CALIFORNIA COASTAL COMMISSION

December 21, 1989

SUBJECT: REVISED FINDINGS ON THE PEPPERDINE UNIVERSITY LONG RANGE DEVELOPMENT PLAN (LRDP) for Public Hearing and Commission Action at the Meeting of January 11, 1990.

EXHIBIT 4 (revised)

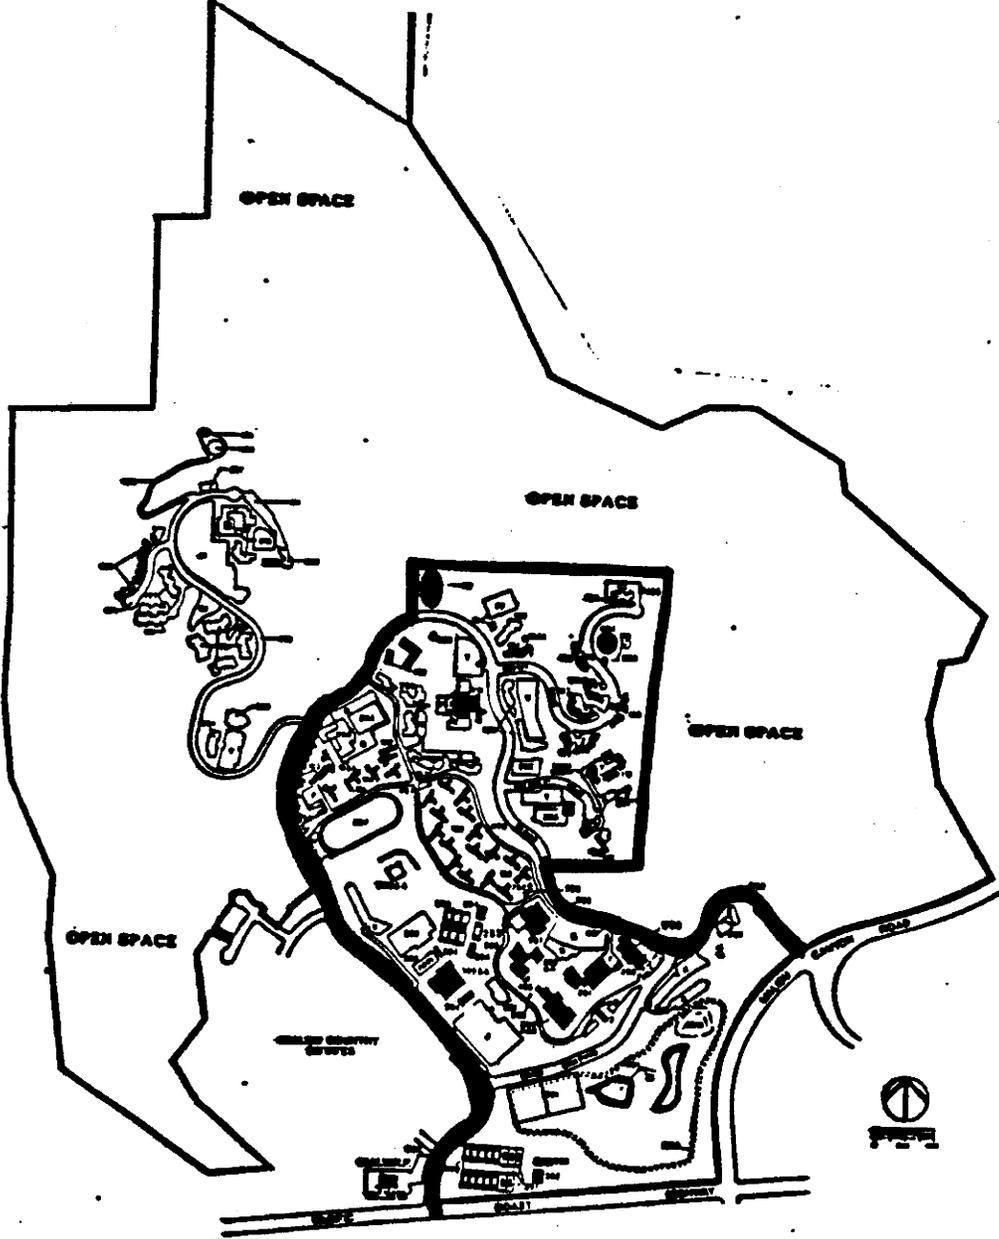
- a. Title the page following Exhibit 1 and preceding Exhibit 2, page 2 as "Pepperdine University LRDP, Exhibit 2, Page 1".
- b. Replace Exhibit 4 with the attached Exhibit 4 which correctly deletes the privately owned Malibu County Estates residential area from the Existing Developed Campus of the University.
- c. Replace Exhibit 5 with the attached Exhibit 5 which removes the approved 72 acre expansion area from the area designated as Open Space.
